Technical / News Bulletin

TB UK066

Subject of Bulletin: Changes to the Safari Brake Lever design

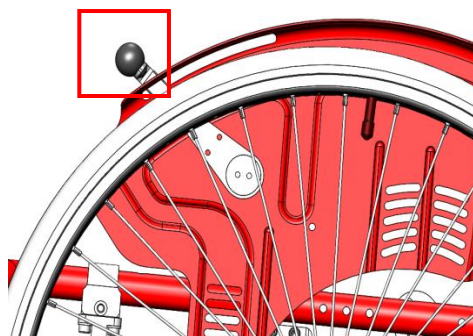
- Based on customer feedback we have changed the design of the 'Safari Brake' lever
- Customers expressed concern that the levers were too long and interfered with the user's arms
- We have reduced the length of the lever by 10mm, this change will be applied to all chairs utilizing this product with immediate effect and with no change to part numbers or order forms.
